Roosevelt E.S. Playground Equipment Project

DSA Application No: 03-125163

ADDENDUM #01

Date Issued: February 11th, 2026

BUILDING 'C' TOILET ROOMS - RENO 1/2" = 1'-0" 3

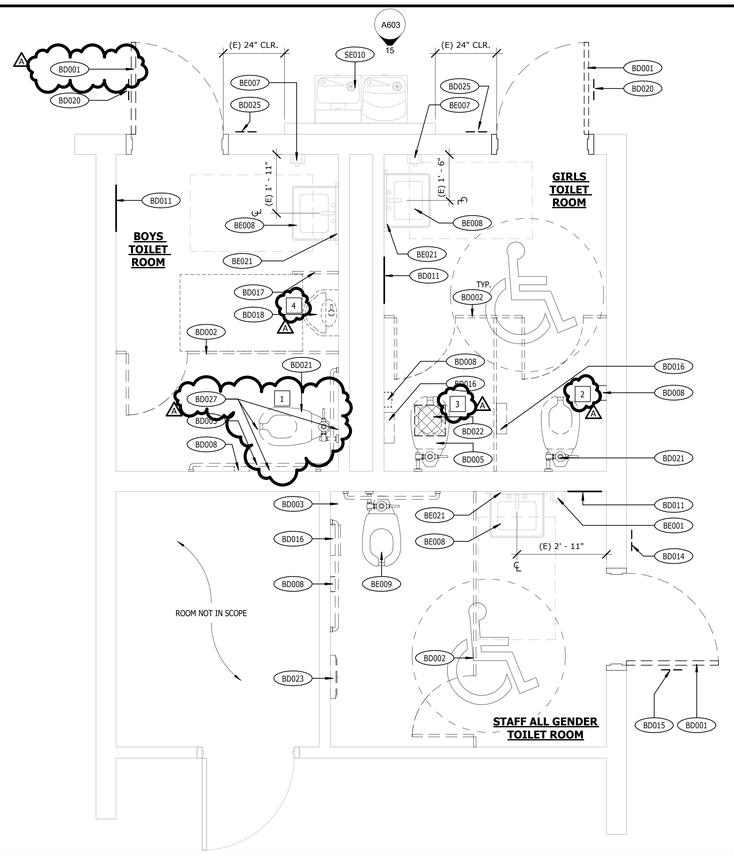
4) A601 Water closet detail for the Girls Toilet Room calls out for BD021 but no call out for renovation. The drawing shows the relocation of the manual flush valve. Please confirm.

5) A601 The plumbing for the ADA water closet in the boys toilet room is shifting from the west wall to the south wall. It is assumed there may be some sawcutting, concrete infill, and floor tile replacements needed. Please confirm.

Answer: Keynote added to plan detail 3/A601 for installation of New water closet, BN009. See additional and revised plumbing notes added to plan details 1/A601 and 3/A601 and sheet A601.

Answer: See additional and revised plumbing notes added to plan details 1/A601 and 3/A601. Notes for tile removal, replacement, and patching have been added to plan details 1/A601 and 3/A601 and sheet A601.

BUILDING 'C' TOILET ROOMS - DEMO 1/2" = 1'-0" 1

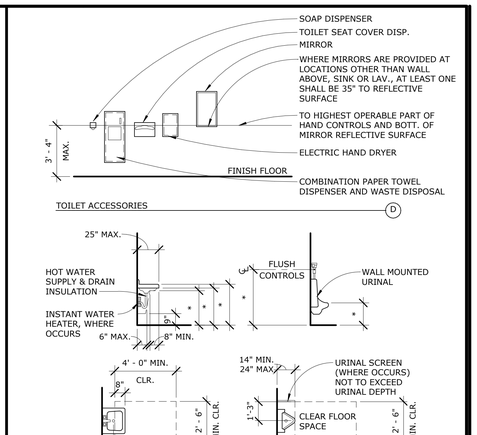
1) A601 BE006 calls out to protect the door in place for demo, however, the same door on the drawing calls out BN001. Please clarify if this door remains or needs to be replaced.

Answer: The existing door is to be removed. The existing frame is to remain and be prepared for a new door with new hardware per A701. Keynote has been changed from BE006 to BD001 on plan detail 1/A601.

Roosevelt Kindergarten
Lawndale, CA

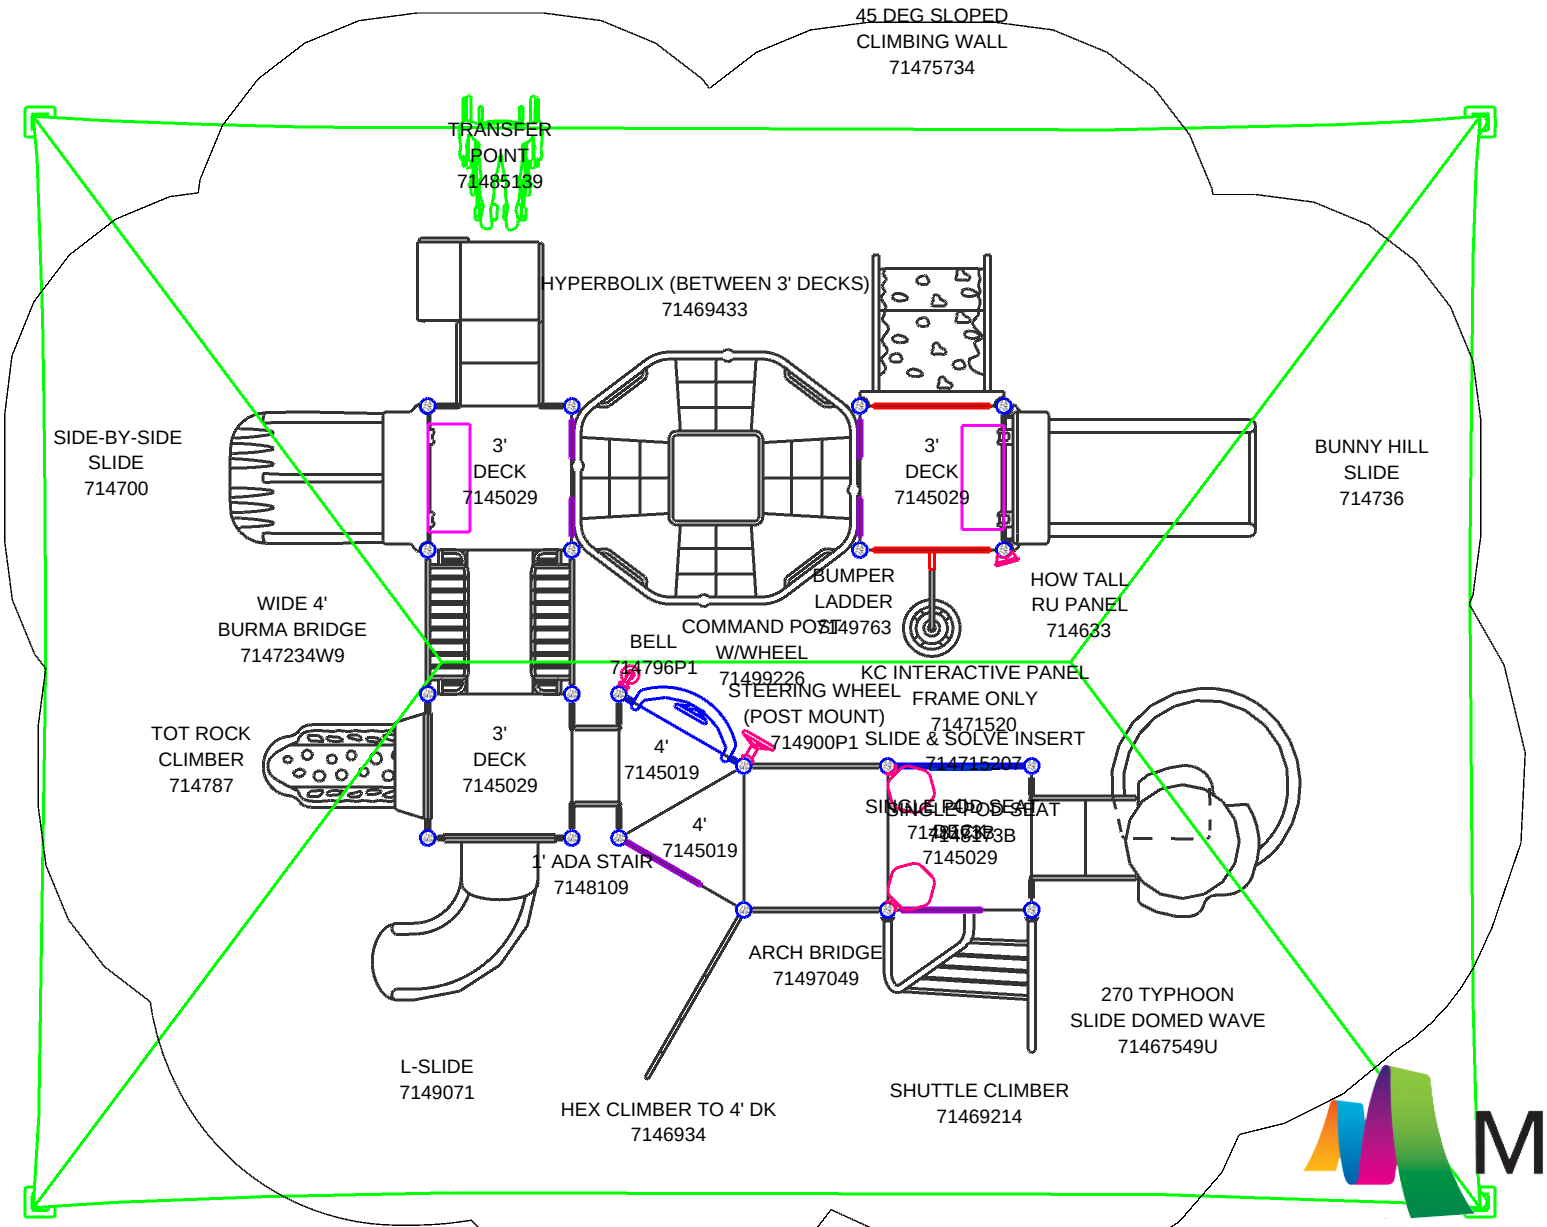
2) A002 & A603 I am unable to locate the specification for the play structure to this project. Please provide clarity on manufacturer and specification.

7) Please advise who is the specified play structure manufacturer approved by district? The plans and specs do not call out any specified play structure manufacturer.

Answer: Miracle Playground; District has the design shown in the plans that is to be purchased and installed by the Contractor. Design documents that were received from District to the AOR for the design have been included in this Addendum. The playground is made up of many different model pieces, and the drawings only show the design intent. Please contact Bryce Lawrence from Miracle Playground at 1.800.264.7225 for the playground equipment quote with estimate number MREC 7815.

Answer: Miracle Playground; District has the design shown in the plans that is to be purchased and installed by the Contractor. Design documents that were received from District to the AOR for the design have been included in this Addendum. The playground is made up of many different model pieces, and the drawings only show the design intent. Please contact Bryce Lawrence from Miracle Playground at 1.800.264.7225 for the playground equipment quote with estimate number MREC 7815.
